Access Report

Tenambit Community Centre
Tyrrell Street
TENAMBIT NSW 2322

For: Maitland City Council
Ref: PAA_23180_Tenambit

Figure 2 | Overall Site Plan

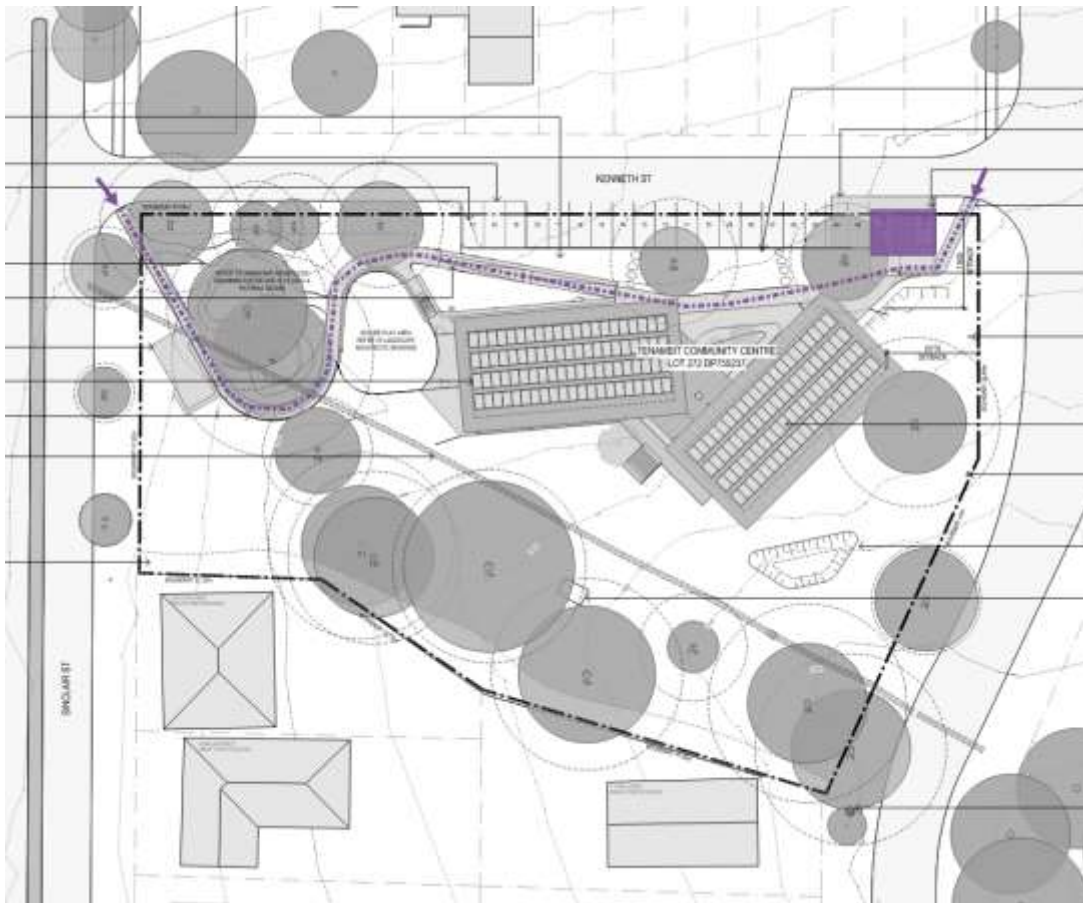
An accessible path of travel is provided to the building entrance from the allotment boundary along Kenneth Street and Tyrell Street via formed footpaths. The existing condition indicates that on-grade access is achievable.

An accessible path of travel is provided to the building entrance via a formed footpath. Site levels indicate that on-grade access is achievable.

Footpaths that form the approach to the building are generally 1500mm wide. Site levels indicate an accessible path of travel.

On grade parking is provided on the northern side of the building. Plans note a total of twenty-one (21) carparking spaces, two (2) of which area nominated as accessible spaces.

A walkway is nominated on the southern side of the western pavilion. It has a nominated gradient of 1:21 and length less than 15m. It is enclosed along one side.

A ramp system provides part of the approach to the building from the western side of the site. The ramp is designed in three sections. The configuration of the ramp is in keeping with accessibility requirements including length between landings, circulation areas at landings and the provision of handrails with extension to both sides. The curved section of the ramp is to have a clear width of 1500mm.

Ensure tactile indicators are provided at the top and bottom of the ramp and that kerbrails are provided as necessary where ramp is not enclosed.
